**Environmental  
Planning  
Commission**

**Agenda Number: 6  
Project Number: 1007099  
Case #: 14EPC-40061  
October 9, 2014**

**Staff Report**

<b>Agent</b>	Dorman + Breen Architects
<b>Applicant</b>	Main Bank
<b>Requests</b>	<b>Site Development Plan for Building Permit</b>
<b>Legal Description</b>	Tracts A-1A & A-1B, Blocks 16 & 17, Zuni Addition
<b>Location</b>	Menaul Boulevard NE, between Mesilla Street NE and Pennsylvania Street NE (7300 Menaul Blvd. NE)
<b>Size</b>	Approximately 1.8 acres
<b>Zoning</b>	SU-1 for C-2 Permissive Uses including full service liquor only in conjunction with a restaurant, excluding the sale of alcohol for off-site consumption and excluding off-premise signs

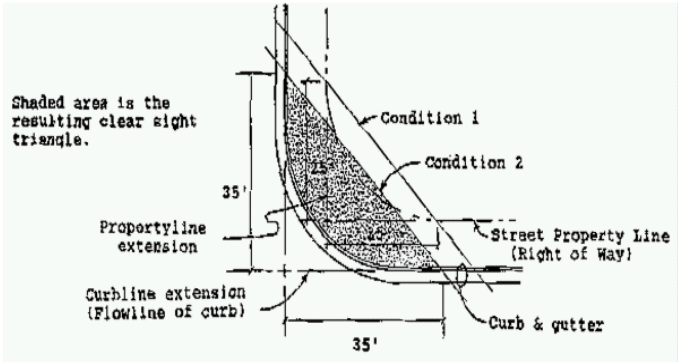
There is a short sidewalk from the east side of the building that ends at the site's main driveway. This sidewalk should connect to something to "accommodate the inter-related movement of vehicles, bicycles, and pedestrians, safely and conveniently, both within the proposed development and to and from the street and the surrounding areas, and to contribute to the attractiveness of the development," (§14-16-3-1(H)).

**Figure 3. Intersection Clear Sight Triangles**

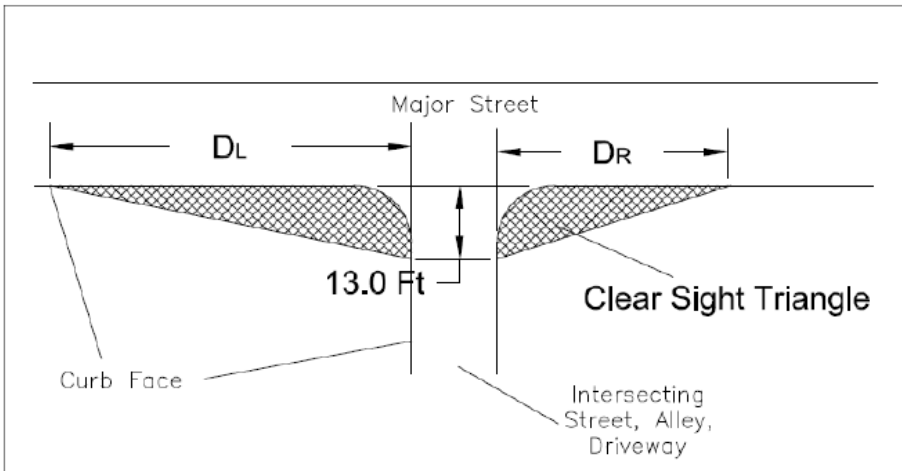
- Work within the public right of way requires a work order with DRC approved plans.
- Show proposed bus stop shelter on Menaul Blvd.
- Clarify purpose of 6-foot sidewalk located on East side of building. Connect to the existing sidewalk along Menaul Blvd. if it is an ADA accessible route.
- Show all parking space widths and lengths as well as all landscape island radii.
- One-way vehicular paths require pavement directional signage and a posted "Do Not Enter" sign at the point of egress.
- The mini clear sight triangle is only appropriate on residential streets.
  - The proposed pylon sign may interfere with the sight distance of the intersection of Menaul and Mesilla. Please provide a sight distance exhibit (see the Development Process Manual, Chapter 23, Section 3, Part D.5 Intersection Sight Distance).

The driveways located on Menaul must use the intersection clear sight triangle as shown here.

1. The Developer is responsible for permanent improvements to the transportation facilities adjacent to the proposed site development plan, as required by the Development Review Board (DRB).
2. Please add the following note to the clear sight triangle: “Landscaping and signage will not interfere with clear sight requirements. Therefore, signs, walls, trees, and shrubbery between 3 and 8 feet tall (as measured from the gutter pan) will not be acceptable in this area.”
